# DEFENSE NUCLEAR FACILITIES SAFETY BOARD

## Staff Issue Report

**SUBJECT:** Design Basis Earthquake Ground Motion Criteria for the Hanford Site and Waste Treatment Plant

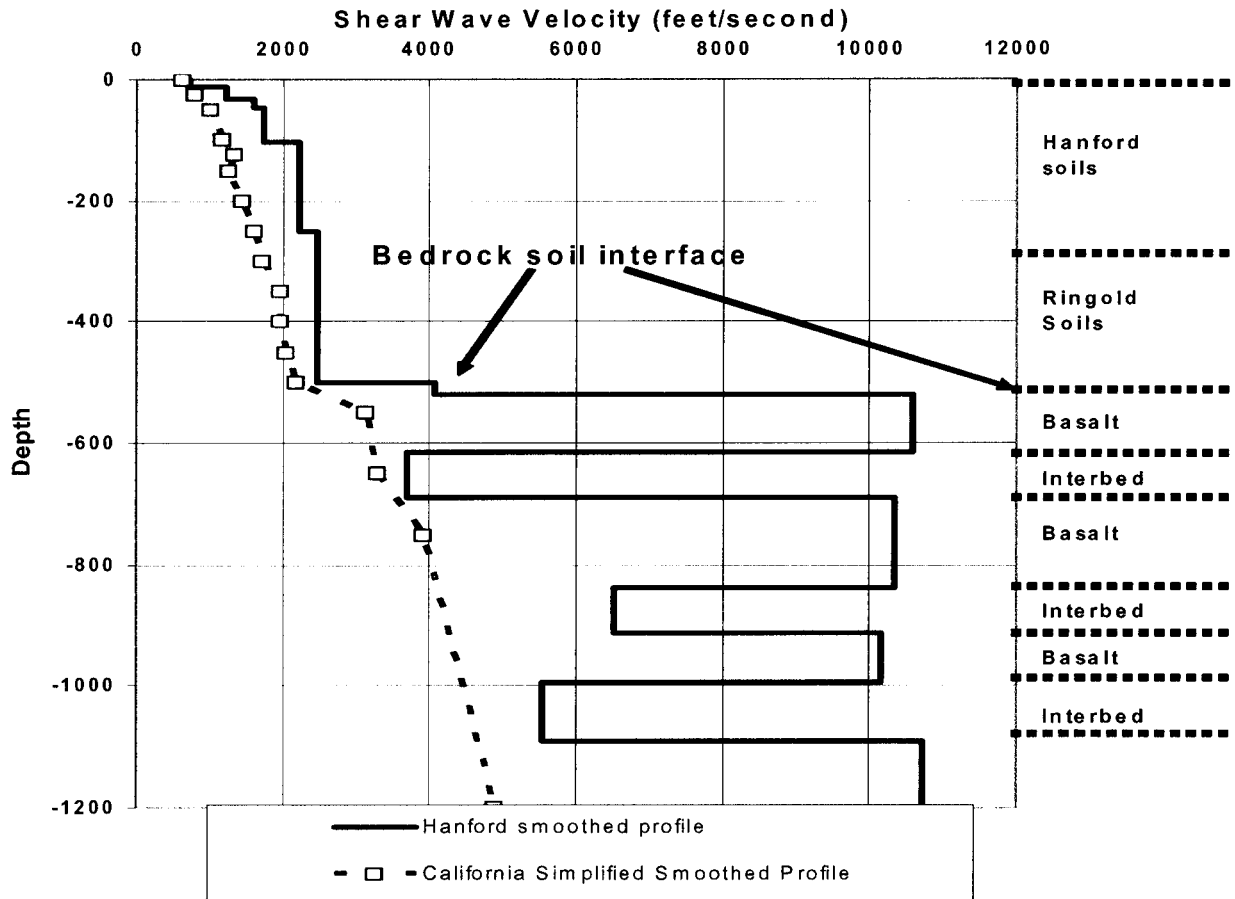
The Board's staff developed Figure 1 from these site response analyses to illustrate the  $V_s$  profile for California and the  $V_s$  profile used for the Hanford site. It is important to note that the Hanford bedrock  $V_s$  profile shown in Figure 1 is based on velocity data taken ~20 km from the WTP site.

However, the Hanford bedrock is not continuous, as seen by the bedrock interbeds shown in Figure 1. The 1996 analysis predicted a significant energy reduction resulting from the arrangement of these bedrock interbeds. This energy reduction counteracted the large soil amplification, resulting in comparable ground motion for Hanford relative to California. Thus the behavior of the bedrock interbeds plays a critical role in determining the site ground motion.

Early assessments conducted by the Board's staff estimated that the site response at Hanford could be about 15 percent greater than that at California sites in the frequency range of 4 to 10 hertz. This was communicated to DOE in the Board's letter of January 21, 2003. However, differences in the characterization of the soils and bedrock at the WTP site could have a significant impact on the difference between the WTP site response and that at California sites. While it may be expected that ground motion changes of up to 15 percent can be addressed by implementing acceptably conservative compensatory design features (e.g., demand/capacity ratio  $\leq 0.85$ ), the same might not be the case if the ground motion were to increase by as much as 50 percent. Thus understanding Vs for the WTP site soil, basalt, and interbeds is essential.
